ADDENDUM

Addendum No. 4

Title: Design-Build Services Department of Public Works/Cromwell Water Pollution Control Authority Facility

TOP VIEW

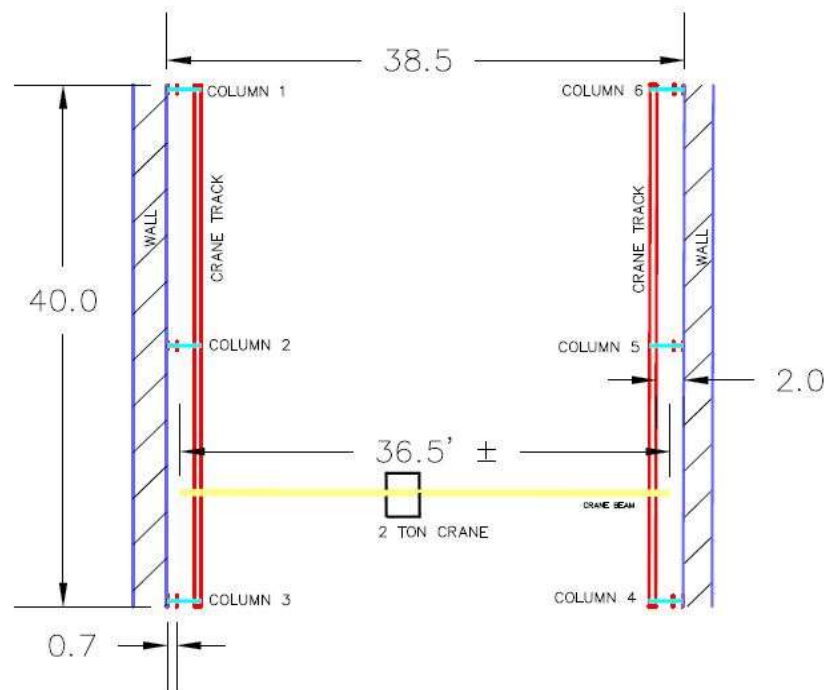
Question 13: For the existing bridge crane please provide the height, length and width and the number of columns.

Response 13: See attached diagram.

17.5' FROM BOTTOM OF TRACK BEAM TO FLOOR
14.5' +/- FROM BOTTOM OF CRANE BEAM TO FLOOR
